Public Service  
Company of Colorado

February 17, 1987  
Fort St. Vrain  
Unit No. 1  
P-87055

SUBJECT: Additional Information  
for Analysis of Firewater  
Cooldown for 82% Power  
Operation

FIGURE 1-1

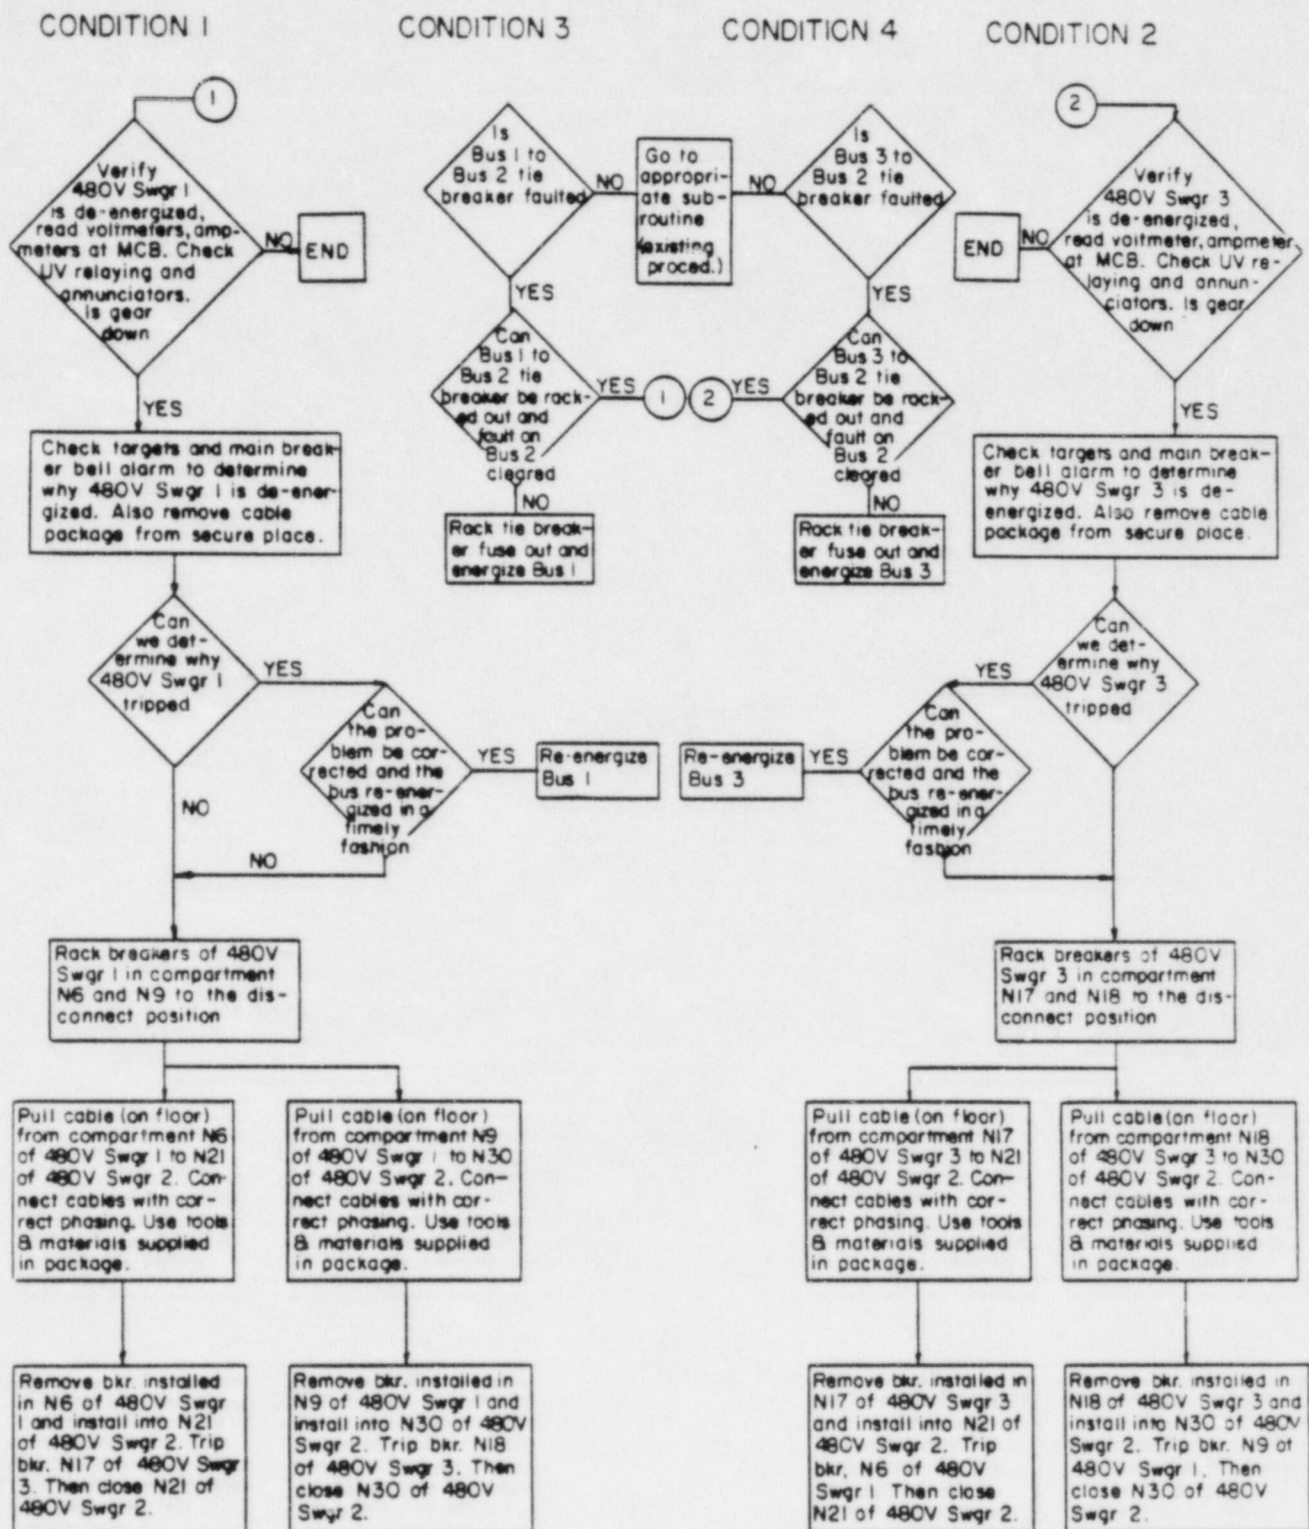
Attachment 4 to P-87002, page 13, describes certain repairs and manual actions that might be required in the event that one loop is incapacitated by a high energy line break and there is a coincident single failure of the power supply for the other loop. Describe the nature of the repairs and associated manual actions. Also, provide a target date for complete implementation of this process including procedures, training and physical plant modifications.

Figure 1-1 provides a flow chart of the actions required to respond to the above described scenario. Since the scenario is identical for either loop, only the conditions associated with a single loop will be addressed in further detail (conditions 1 and 3 or conditions 2 and 4). It should be noted that all required manual actions to respond to the combination of events are confined to a mild environment (i.e., the 3-room complex).

Condition 1 is the failure of the Essential Bus 1 due to a breaker failure, insulator failure, EDG set failure or any other malfunction causing loss of power to that bus. The required actions are to diagnose and determine the cause of the Bus 1 failure, and if it cannot be re-energized in a timely manner, then the following interim measures are taken:

- \* Rack out the supply breakers for helium circulator bearing water pumps P-2101 and P-2106 (switchgear compartments N6 and N9 of 480 VAC Essential Bus 1) to the disconnect position.
- \* Pull one of the two cables from compartment N6 of Bus 1 to compartment N21 of Bus 2 (spare compartment). Pull the other cable from compartment N9 of Bus 1 to compartment N30 of Bus 2. Connect the cables to the load side of the breaker cubicle in each bus. This configuration utilizes Bus 1 as a junction box to provide the required power connection to the pumps.
- \* Remove the racked-out breakers from N6 and N9 (Bus 1) and install in compartments N21 and N30 (Bus 2). Trip the supply breakers in compartments N17 and N18 of Bus 3 which feeds bearing water pump P2107 and P2102 of the incapacitated loop. Close the breakers in compartments N21 and N30 of Bus 2.

Condition 3 is the gross failure of the bus tie breaker between 480 VAC Essential Buses 1 and 2. During operation with the EDG sets, the bus tie breaker fuse is not designed to interrupt for faulted conditions. This gross failure could result in both Buses 1 and 2 being de-energized (worst case). Again, the required actions are to diagnose and determine the cause of bus tie failure. If re-energization or fault clearing can not be achieved through existing procedures in a timely manner, then the following action is required:

- \* Rack out the bus-tie breaker fuse. This isolates the bus-tie-breaker from Bus 1.
- \* Re-energize Bus 1 to supply power to the required bearing water pumps.

The procedure, procedure training and the required cable package will be in place by March 1, 1987. It should be noted that the final procedure may differ slightly from the flow chart but the required manual actions are still the same.

Figure 9-1

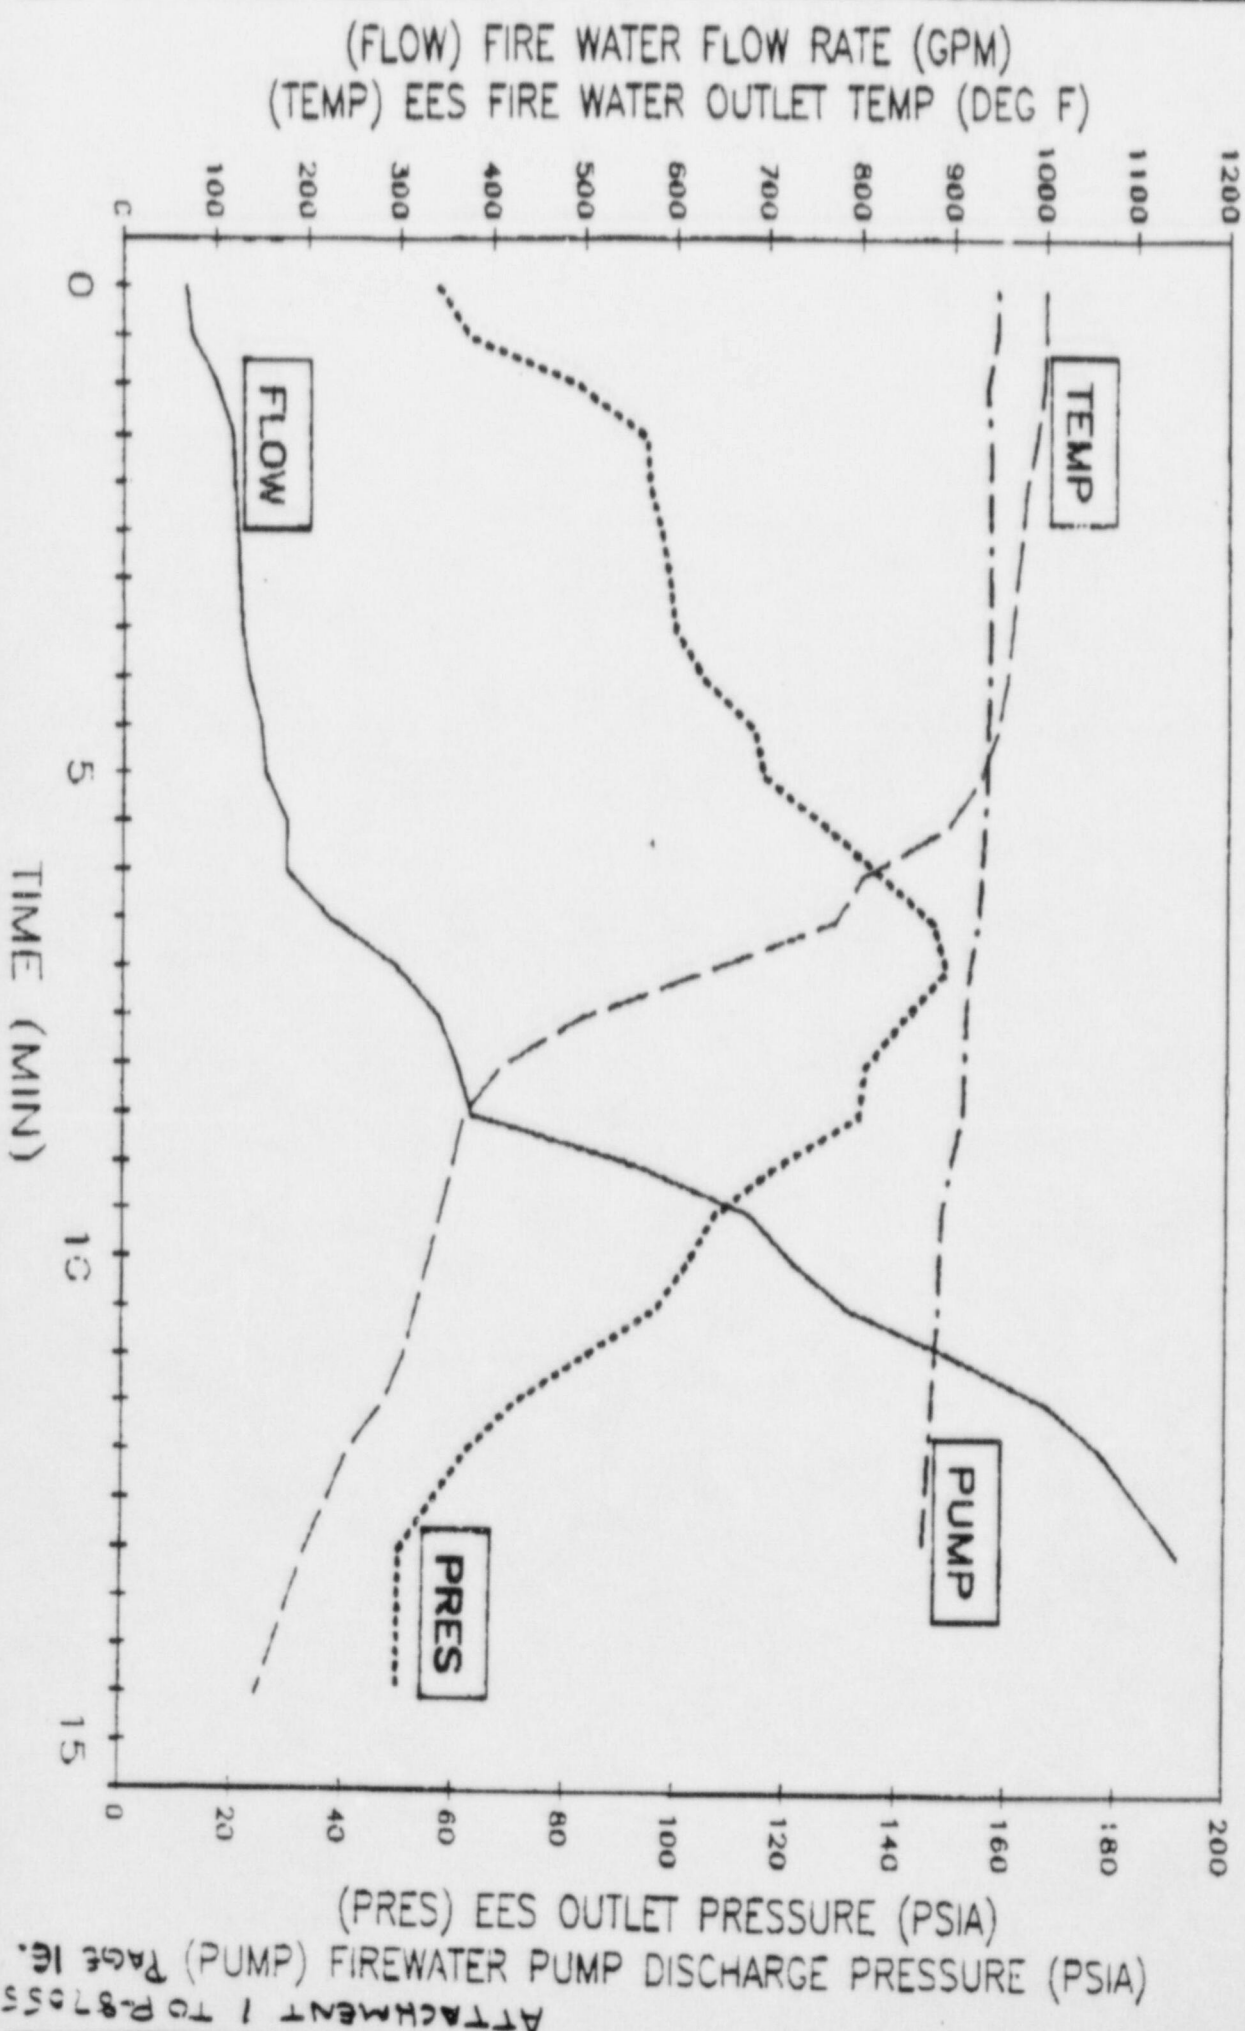
Justify the absence (or lack) of transient calculations for the firewater flows.

An analysis of the firewater system flow, pressure and temperature through an EES section of the steam generator during an Interruption of Forced Cooling (IOFC) has been performed. The analysis was performed in order to predict the time required to sufficiently cool an EES section after a 90 minute IOFC such that subcooled liquid flow is established through the secondary cooldown loop. Adequate subcooled liquid flow is required at the EES outlet to prevent boiling in the EES tubes when forced helium circulation is restored. The analysis is documented in Proto-Power Calculation No. 82-10, dated 11/25/86. (Submitted to the NRC in Attachment 9 to PSC letter P-86682, dated December 30, 1986.)

The results of the cooldown analysis are shown on Figure 9-1. The analysis predicts that liquid flow through the cooldown path is achieved about 14 minutes after flow is initiated. It is also noted that an independent analysis by GA Technologies was also performed to predict EES flooding times. The GA Technologies analysis (GA Document No. 909306, Issue N/C, Draft, dated 12/23/86) reported that liquid flow is obtained through the loop 8 minutes after flow is initiated. The Safe Shutdown Cooling procedures have conservatively been based on the longer 14-minute cooldown time.

The initial metal temperatures used in the analysis ranged from about 400 degrees F in the feedwater piping, 610 degrees F to 730 degrees F in the EES section and 1000 degrees F in the main steam piping. EES metal temperatures are based on calculated values following a 90 minute IOFC after indefinite operation at 105% reactor power. Feedwater piping and main steam piping temperatures are conservatively based on fluid conditions at 100% reactor power, per Fort St. Vrain Process Flow Drawing PF-2-12, Issue A. Therefore, the analysis results are valid following operation from full reactor power.
